RIGHT OF WAY PLAN OF THE HOLBROOK - SPRINGERVILLE STATE HIGHWAY

PROJECT NO. F-051-1-809

APACHE COUNTY

HOLBROOK — SPRINGERVILLE HWY.
BEAVER DAM WASH — HUNT SECTION
APACHE COUNTY

PROJECT NO.	F-051-1-809
DRAWING NO.	D-1-T-241
SHEET NO.	2 of 23
DRAWN BY	H.H.
DATE COMP.	8-29-69
SCALE	
CONSULTANT	GREER ENGR. CO.

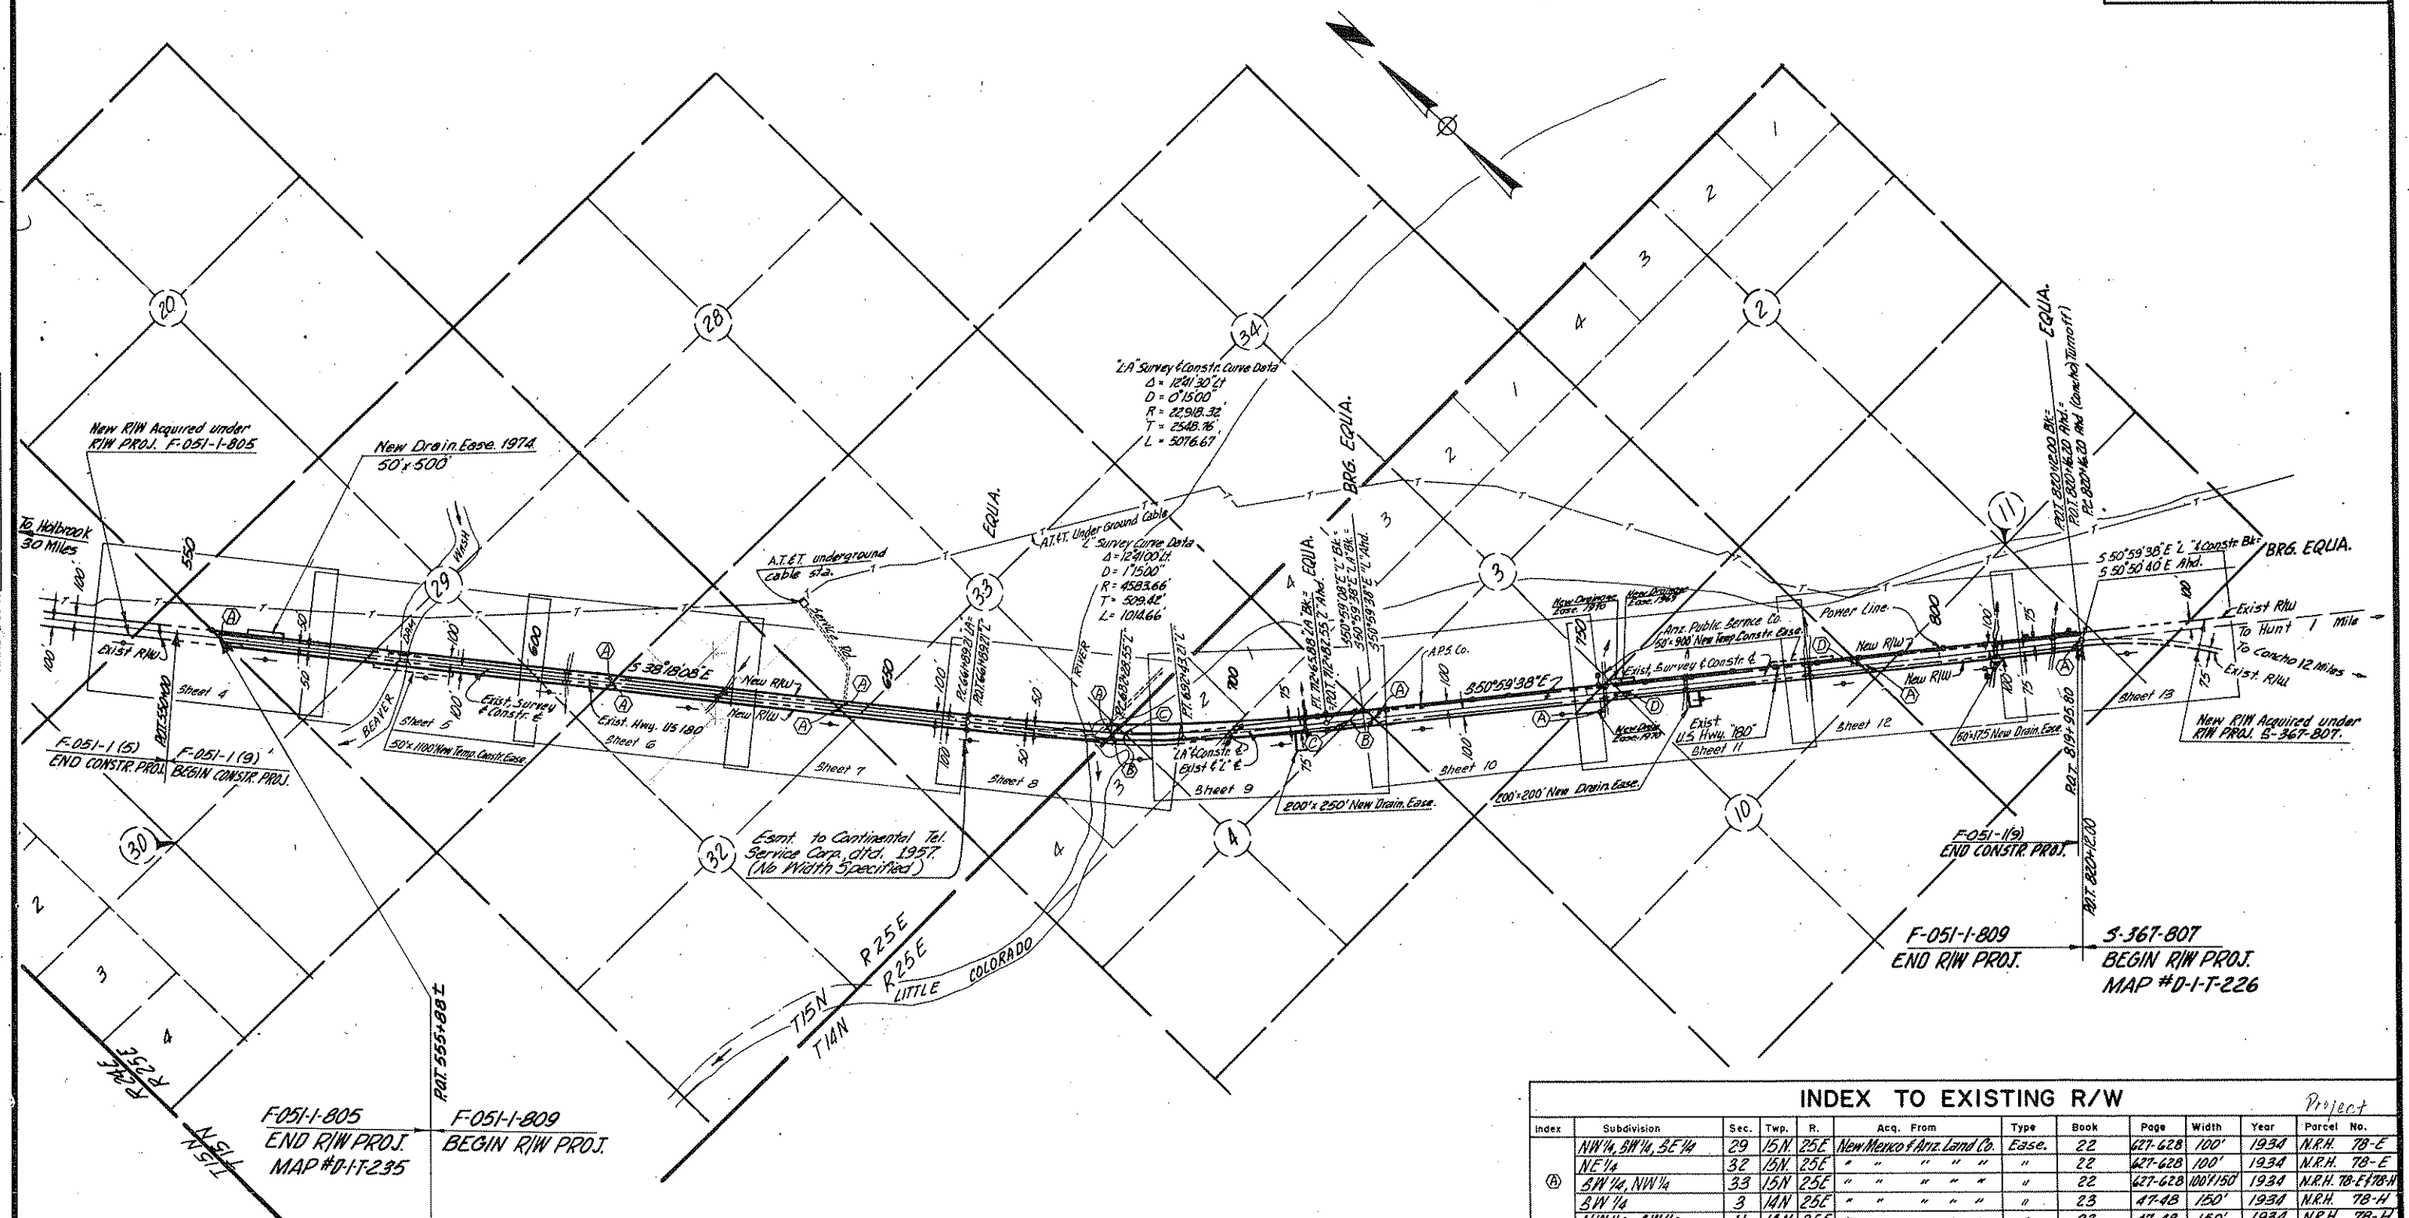
REVISIONS			
C O No	DATE	BY	DESCRIPTION
2646	4-14-70	Marin	Changed Drawing No.
2662	7-16-70	R.R.	Added Parcel 1-108-A-New Drainage Easement fe.
2666	7-27-70	W.TRICK	Changed owner of Parcel 1-106
4083	10-28-74	A.M.M.	Added Par. 1-105-A.

PROJECT NO.	F-051-1-809
DRAWING NO.	D-1-T-241
SHEET NO.	4 of 23
DRAWN BY	E.B.S.
DATE COMP.	8-29-69
SCALE	1" = 100'
CONSULTANT	GREER ENGR. CO.

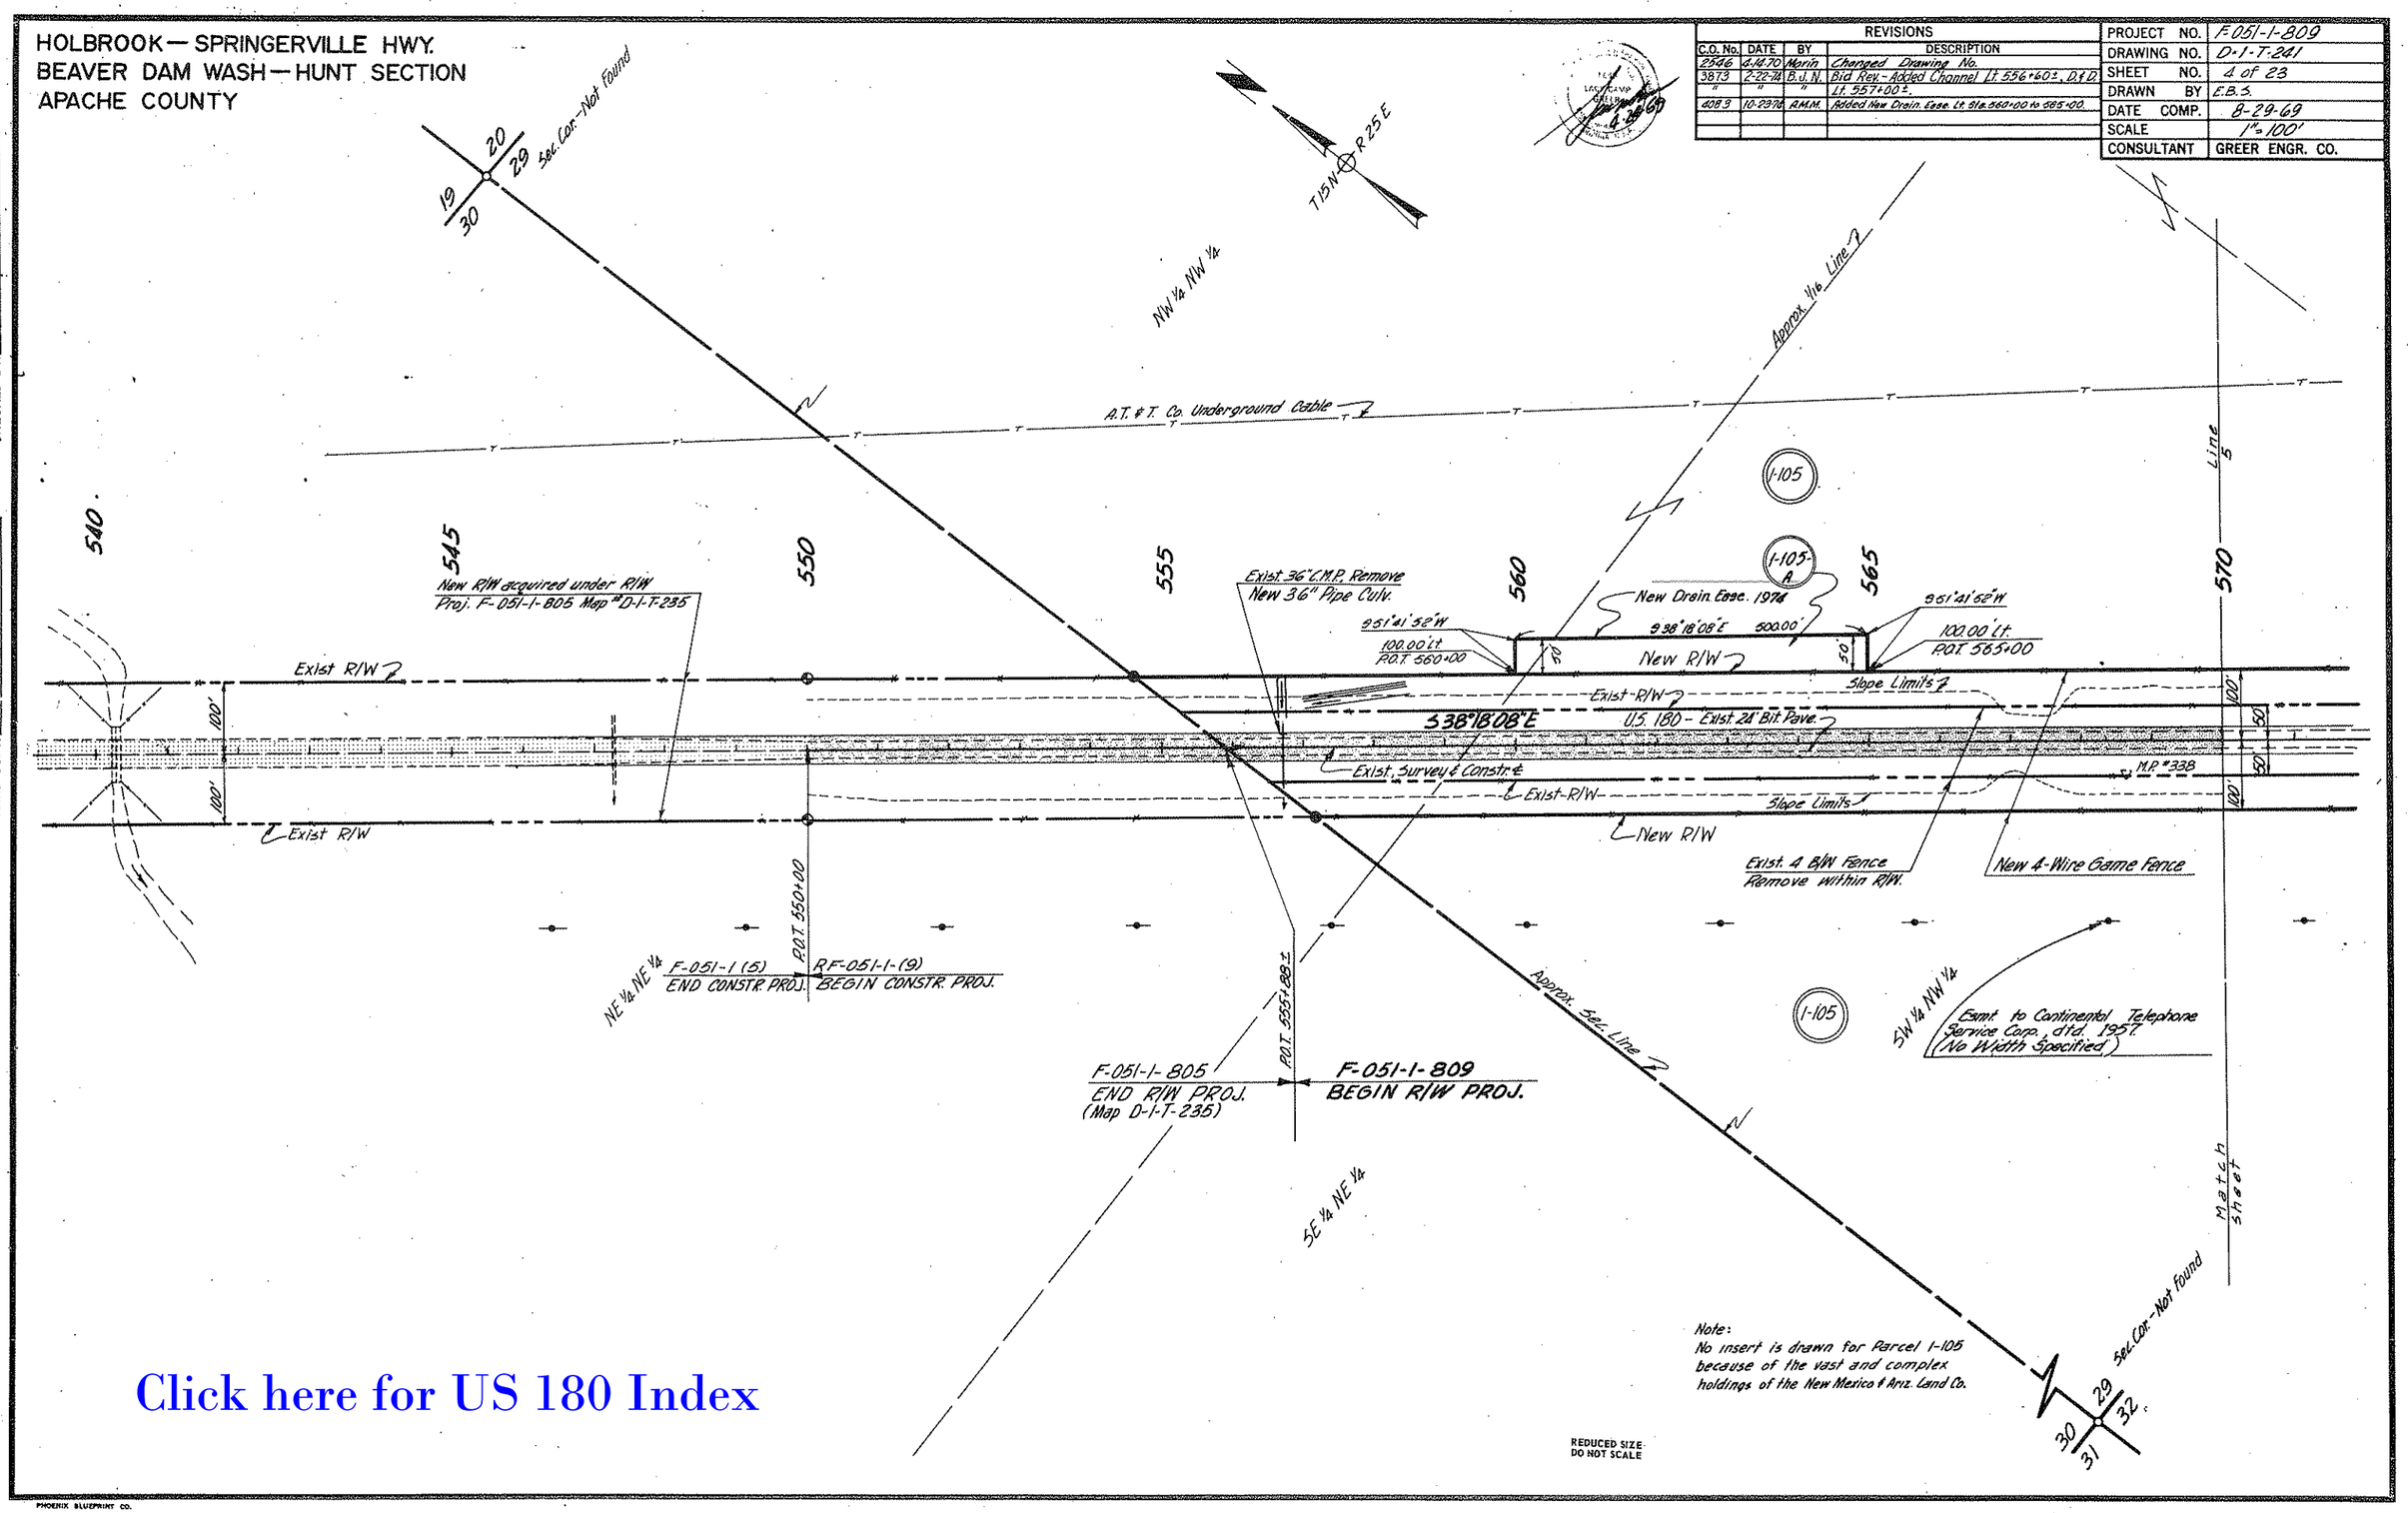
REVISIONS			
C.O. No.	DATE	BY	DESCRIPTION
2546	4-14-70	Morin	Changed Drawing No.
3873	2-22-74	B.J.N.	Bid Rev.-Added Channel Lt. 556+60±, D&D
"	"	"	Lt. 557+00±.
4083	10-29-76	A.M.M.	Added New Drain. Easе. Lt. Sta. 560+00 to 565+00.

PROJECT NO.	F-051-1-809
DRAWING NO.	D-1-T-241
SHEET NO.	5 of 23
DRAWN BY	E.B.S.
DATE COMP.	8-29-69
SCALE	1" = 100'
CONSULTANT	GREER ENGR. CO.

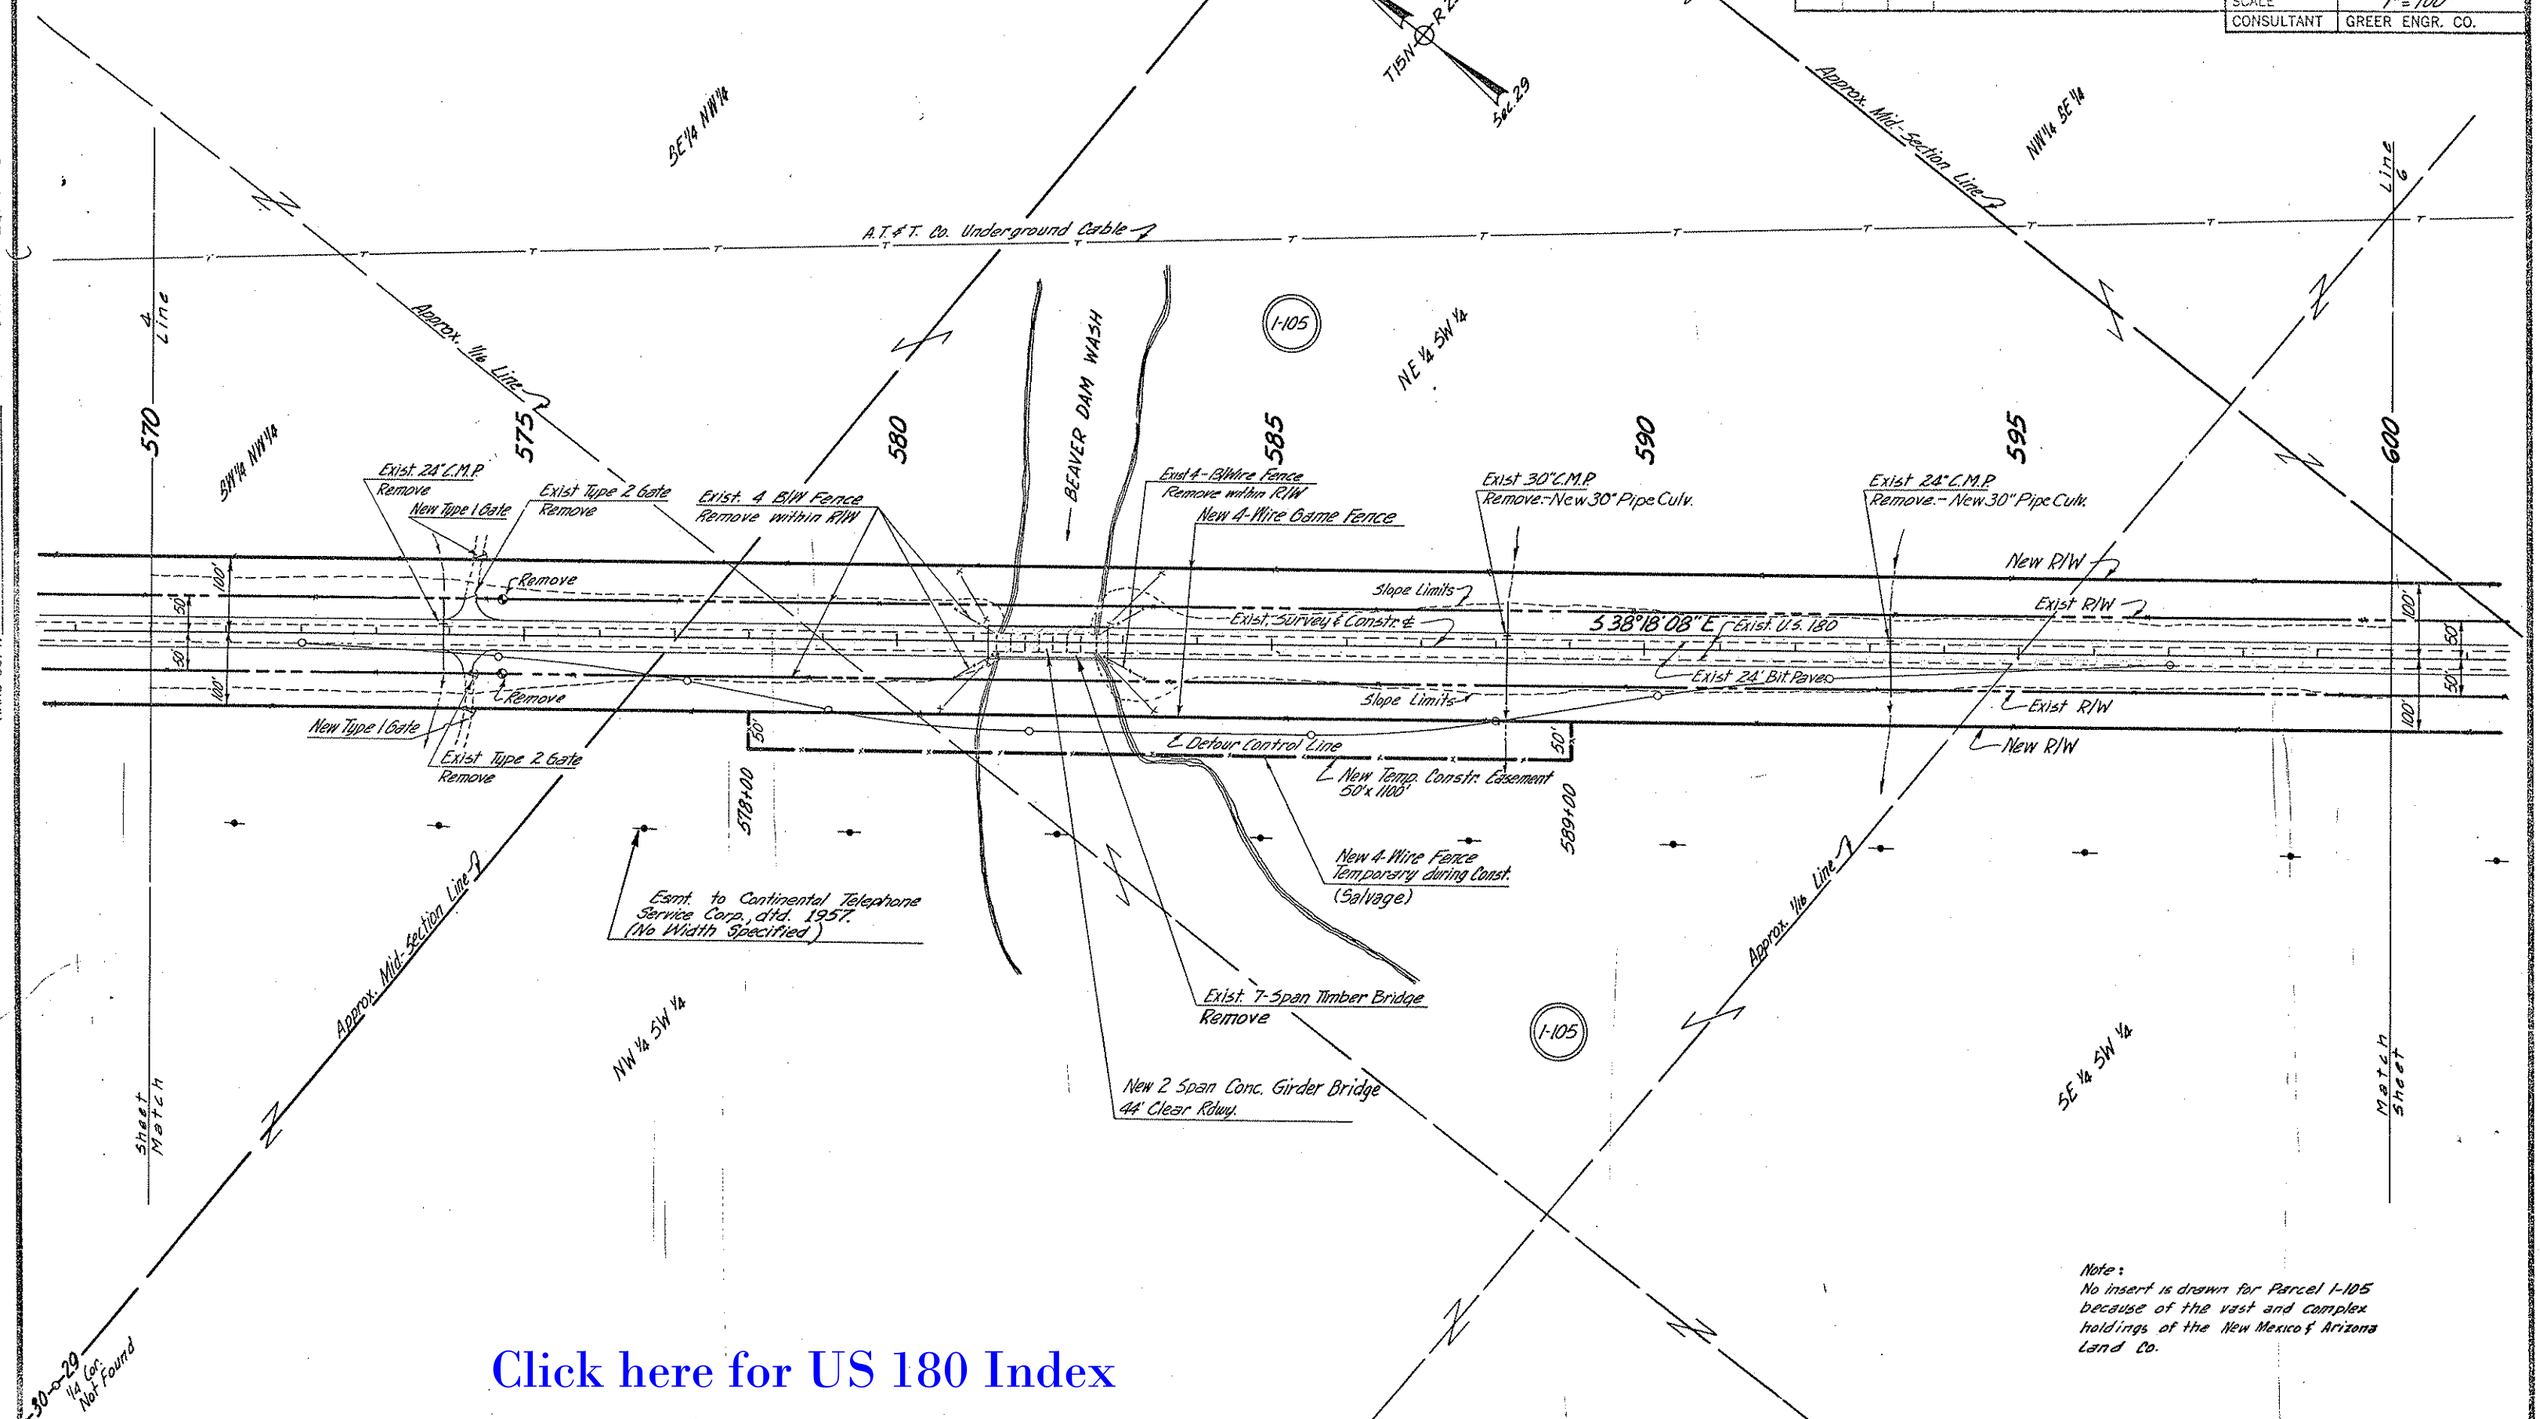
REVISIONS			
C.O. No.	DATE	BY	DESCRIPTION
2546	4-14-70	Morin	Changed Drawing No.
2662	7-16-70	R.R.	Changed 40' Clear Rdwy. to 44' For Brdg.
"	"	"	on Beaver Dam Wash.
3732	10-19-73	R.R.	Called out "New 30" Pipe Culvs."
3873	2-23-74	B.J.N.	Bid Rev.- Revised Bridge & Fence Calls.
